Letter to the Editor/Article for publication in 'Roundabout'

This letter is a response to a paper entitled *Pedestrian Safety – Left Turns at Signals - Research Study* (the 'conference paper') by Bruno Royce of Traffic Engineering Solutions Ltd (TES), presented at the ENZ TG Conference in Wellington in March 2019 - I was informed just after the conference of the commissioned paper and the direction of the results and recommendations in it. I obtained a copy of the paper, and, on reading the paper, I was most surprised at the results which were diametrically opposite to those we (O'Brien Traffic) found in a major peer reviewed study published by the US Transportation Research Board in Transportation Research Record No. 2299 - Pedestrians (2012).

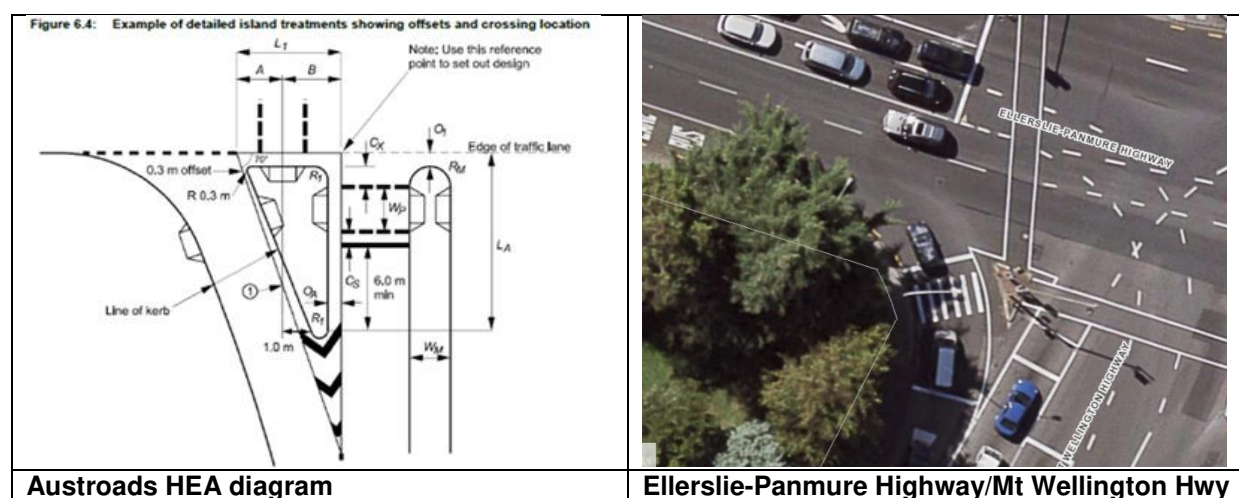
I reviewed the 2018 TES research report (the 'research report') on which the conference paper was based. In the research report I saw that one HEA site had 3 recorded crashes, which I considered to be most unusual. On examining the Appendix C table in that report, it was clear that the treatment at this site had been originally coded as C8 (low-entry-angle (LEA)), but later re-classified to C7 (HEA). The Austroads HEA typical design, and an aerial photo of the subject site are shown below.

Some differences between the photo and the diagram are obvious: the length of the island – about 3 m compared to a minimum of about 10 m, the continuous sharp radius curve on the right side of the slip lane compared to the straight side in the HEA diagram, and the area of

the islands. At the site, the pedestrian crossing is just prior to the holding line, compared to best practice which is to be a car length back from the holding line (as per roundabout design guidelines), but which is not shown in the Austroads diagram. This site has clearly been 'mis-coded'.

Two of the locations with a total of 7 wrongly-coded left turn treatments (C8 instead of C7), and that also had crashes, are shown below.

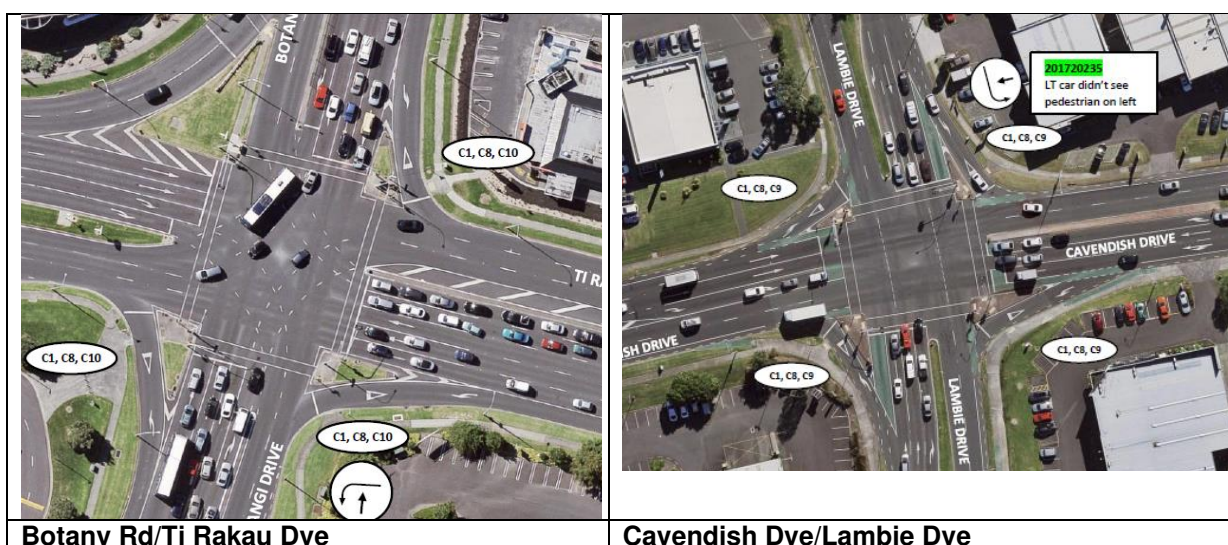
Given the mis-coding of the above site, I then decided to check if other slip lane sites had been mis-coded as HEA. To my surprise, I found the opposite - 91 approaches were coded as LEA instead of HEA and that clearly complied with the Austroads diagram of a HEA slip. There were many others that arguably complied as HEA slips. I reassessed the latter group, and this added a further 69 HEA sites, resulting in a total of 281 HEA sites with 1 minor injury crash and 2 non-injury crashes. But 16 sites that should have been coded as LEA ones were wrongly classified as C7 (HEA) - reducing the overall number of HEA sites to 265.
